SERVICE INFORMATION NO. SI 20-027

BRP-Rotax ASB-912-053
ATA-Code: 73

ALERT SERVICE BULLETIN
REPLACEMENT
OF FUEL PUMP
FOR ROTAX® ENGINE TYPE 912 (SERIES)
SB-912-053

(see Fig.1)

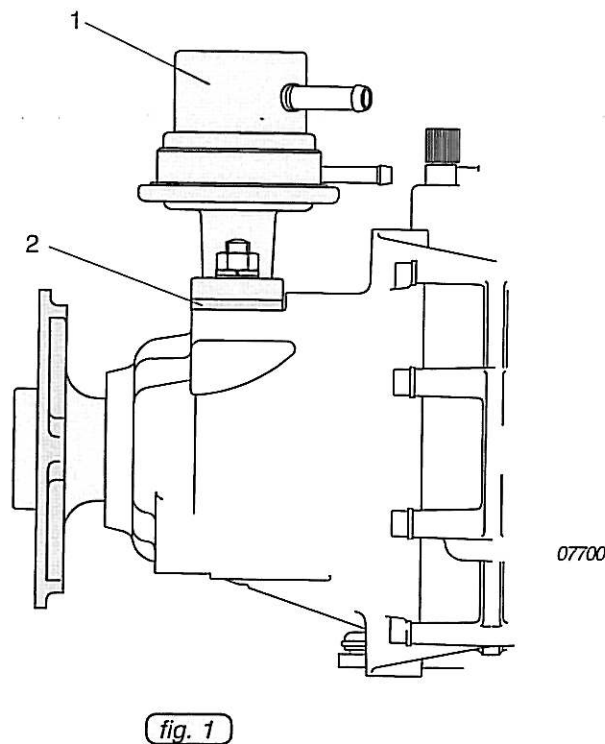
1. Remove fuel pump (1).

2. Gasket (2) replaced by new part.

■ **CAUTION:** Install new gasket supplied with new fuel pump. The thickness is different.

3. Install fuel pump. Tightening torque 15 Nm (133 in.lb).

4. Install fuel line.

Replacement of fuel pumps with part no. 892230, 892232, 892540 through part no. 892542 and

Replacement of fuel pumps with part no. 892235, 892236, 892545 through part no. 892546 for ROTAX® engine type 912 (Series).
